# Proposed Changes to State Diagrams

April 3, 2019

# “pcs\_data\_mode” in Clause 55 vs. Clause 149 D1.2

# Figure 149-33 PHY Control state diagram

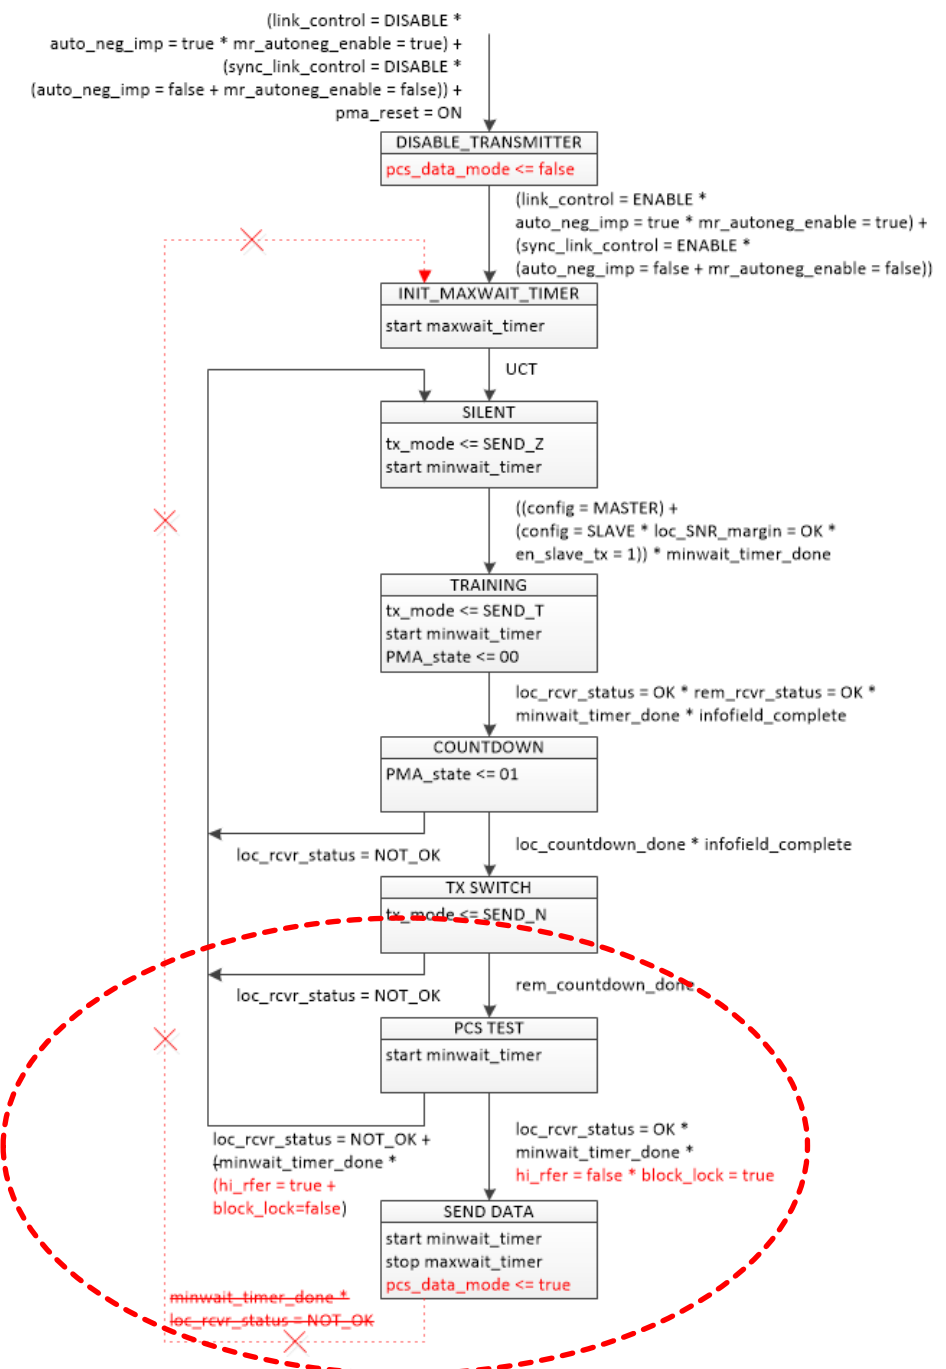
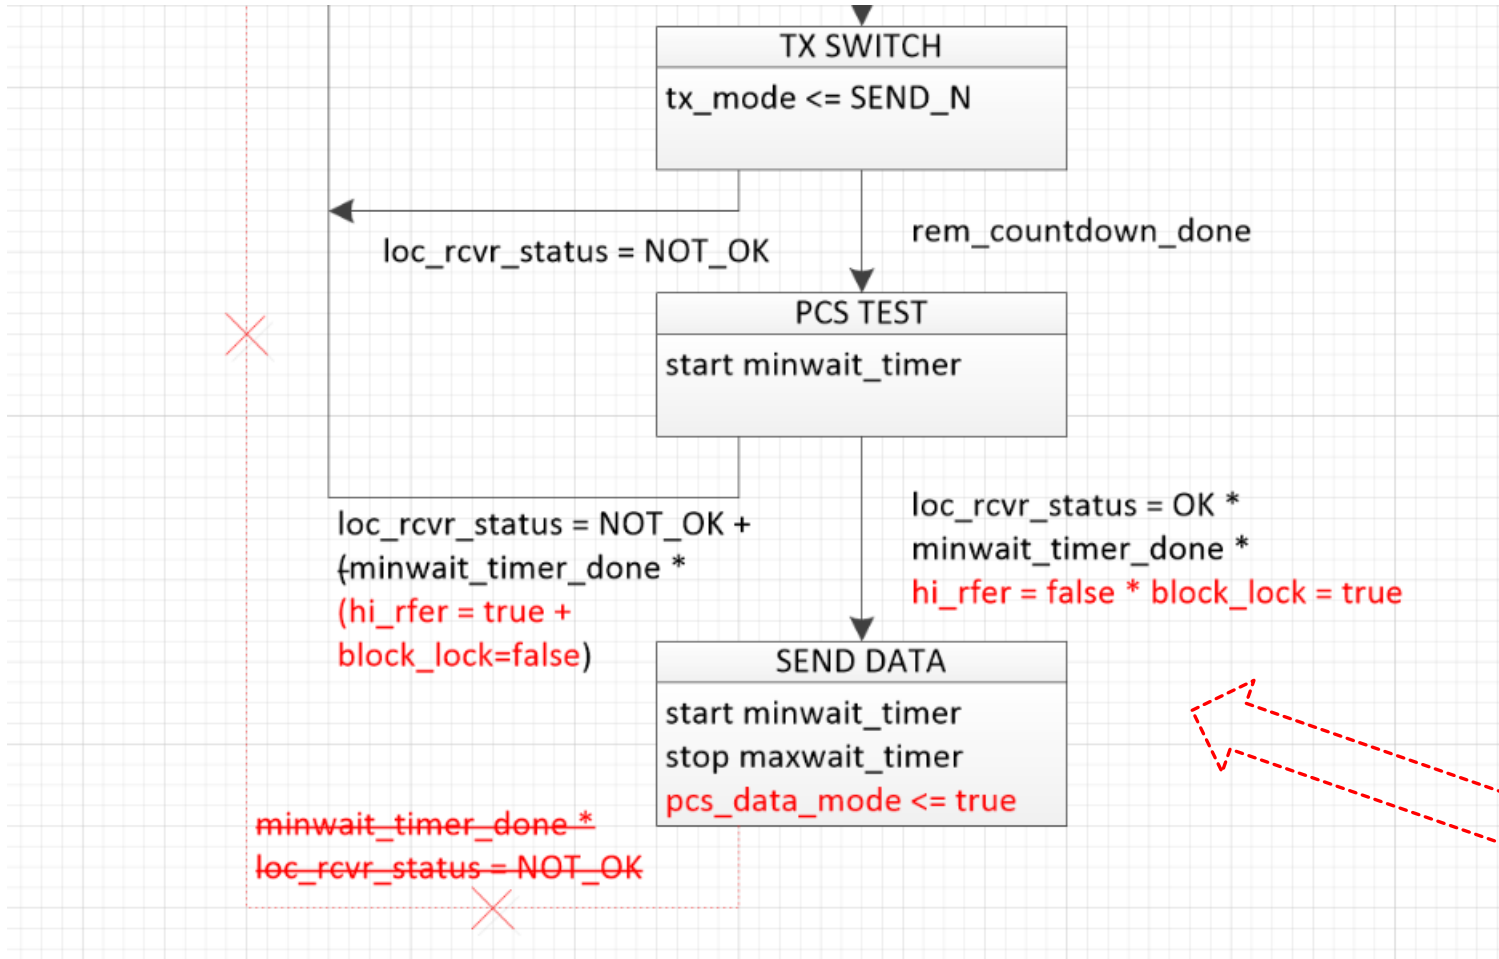
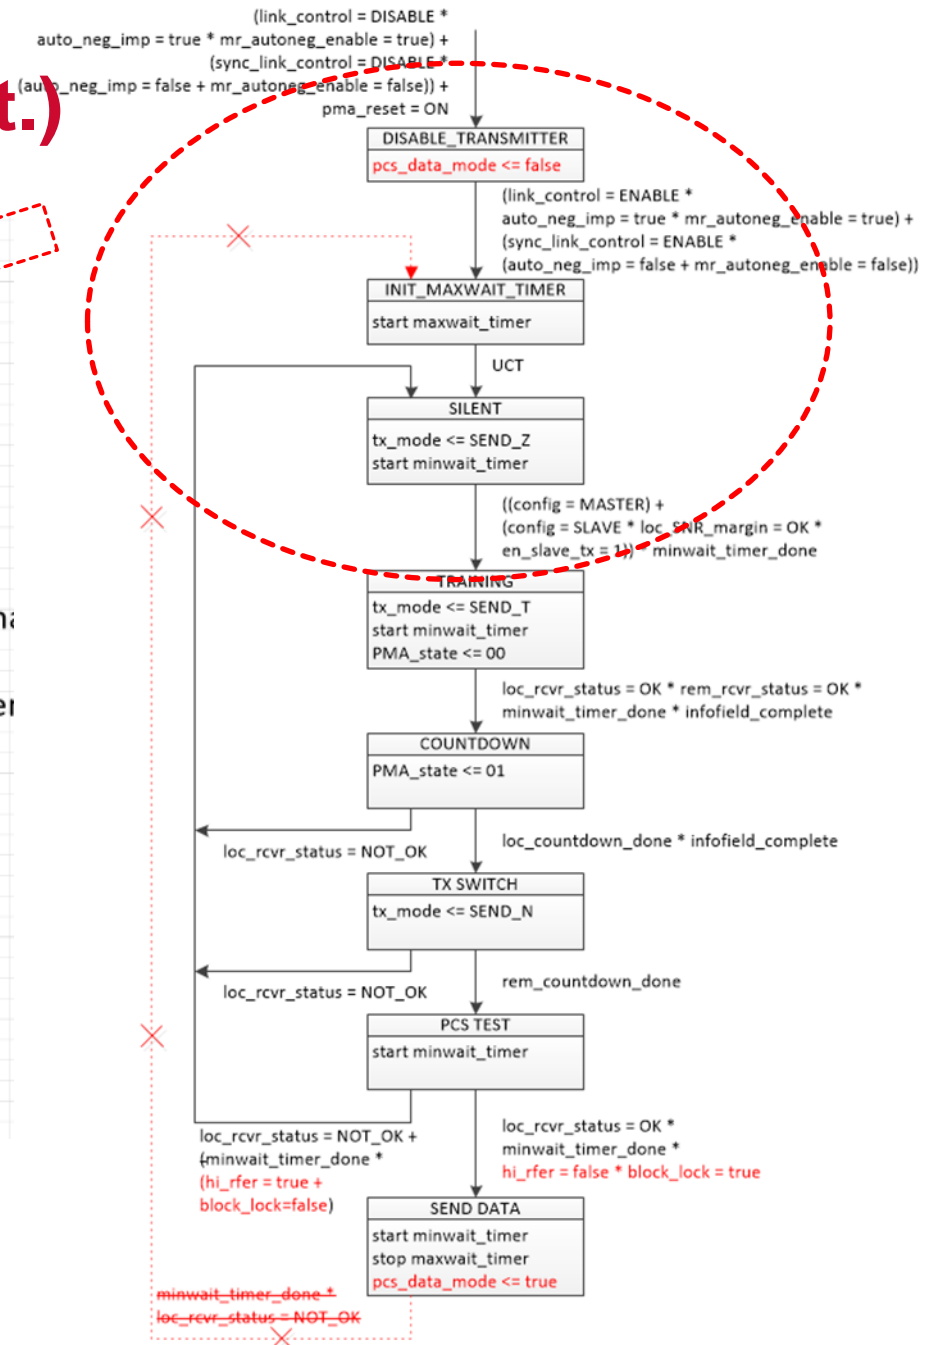
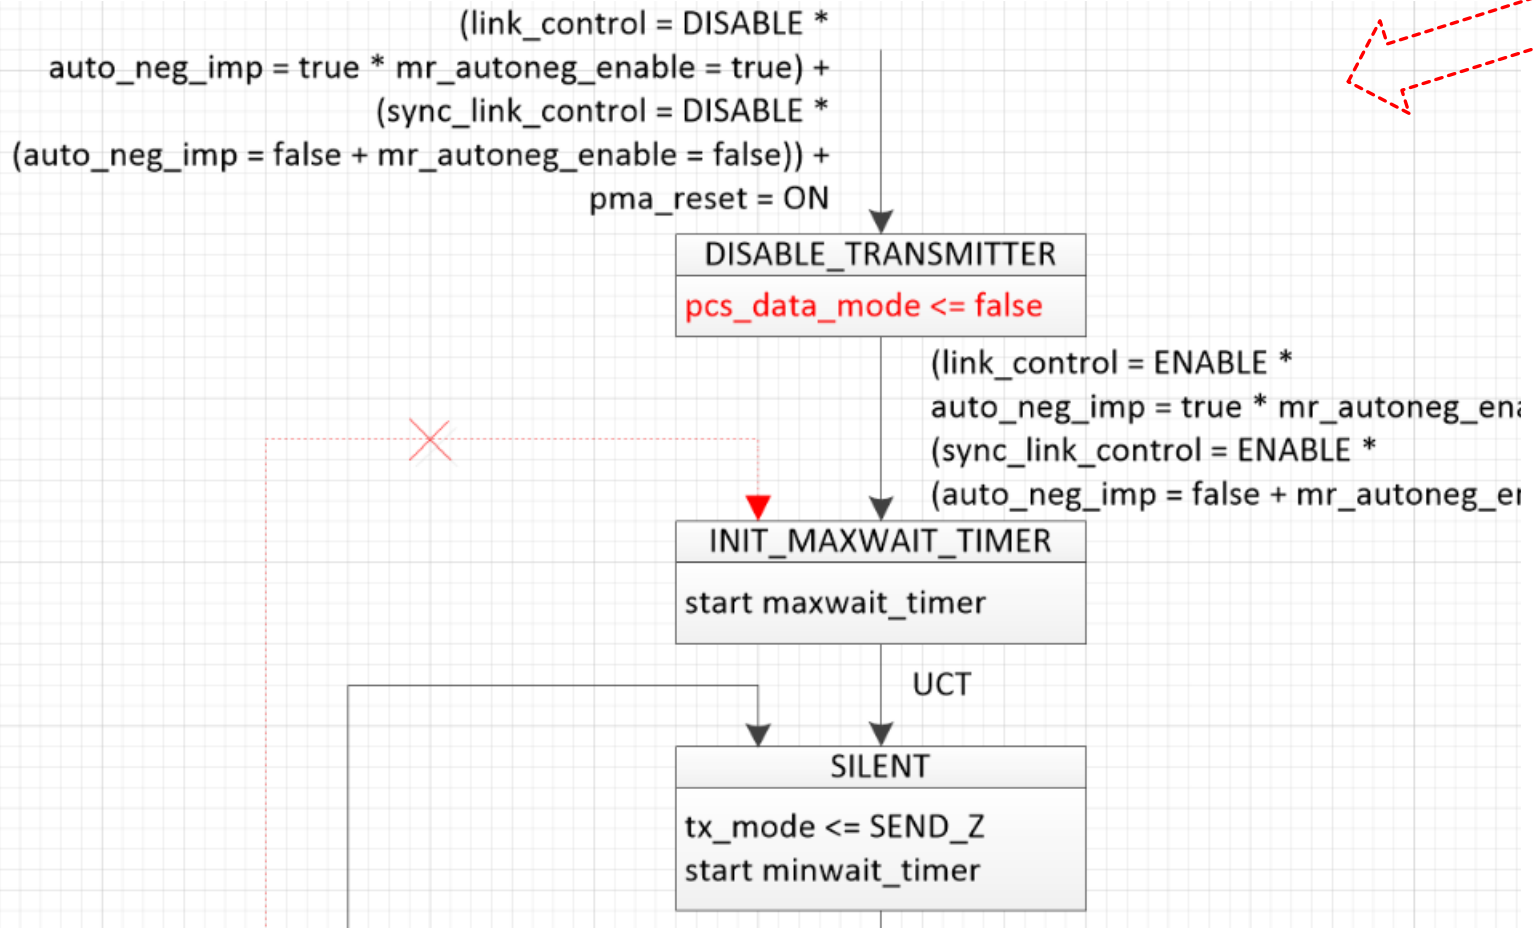
# PHY Control State Diagram Changes

# PHY Control State Diagram Changes (cont.)

- In Figure 149-2, add “pcs\_data\_mode” coming out of “PHY CONTROL”, and enters “PCS TRANSMIT”.
- In Figure 149-4, add “pcs\_data\_mode” entering from “PMA SERVICE INTERFACE” into the “PCS TRANSMIT”. See Figure 55-5 for reference.
- In Figure 149-26, add “pcs\_data\_mode” coming out of “PHY CONOTRL” and going up to the PMA SERVICE INTERFACE”. See Figure 55-21 for reference.
- In Figure 149-33, PHY Control State Diagram:
  - In “DISABLE\_TRANSMITTER” state, add “pcs\_data\_mode <= false”.
  - In “SEND DATA” state, add “pcs\_data\_mode <= true”.

# Figure 149-34 Link Monitor state diagram

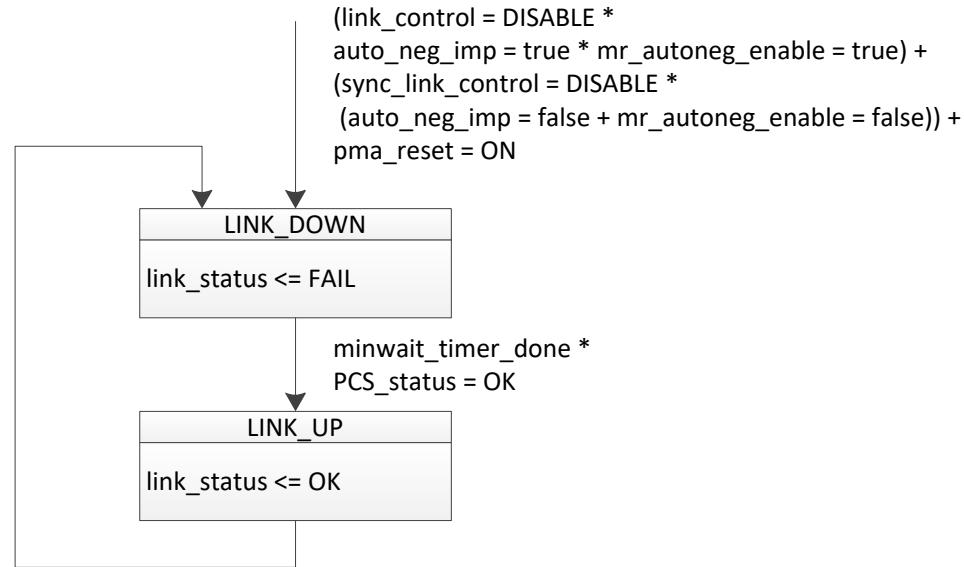
- PCS\_state is dependent on pcs\_data\_mode now. So it will enter LINK\_UP only after pcs\_data\_mode is true
- The maxwait\_timer would have been stopped when PHYC enters “SEND\_DATA” state → do not check for “maxwait\_timer\_done”.
- If link\_status drops to FAIL, autoneg or LINK SYNC state machines will take over and restart link attempt.

~~maxwait\_timer\_done \*~~  
 (PCS\_status = NOT\_OK + loc\_rcvr\_status = NOT\_OK) +  
 PMA\_refresh\_status = FAIL+  
~~PMA\_watchdog\_status = NOT\_OK~~

~~NOTE 1 – maxwait\_timer is started in PHY Control state diagram (see Figure 149-16).~~

NOTE 1 – The variables link\_control and link\_status are designated as link\_control\_mGigT1 and link\_status\_mGigT1, respectively, by the Auto-Negotiation Arbitration state diagram (Figure 98-7) if the optional Auto-Negotiation function is implemented.
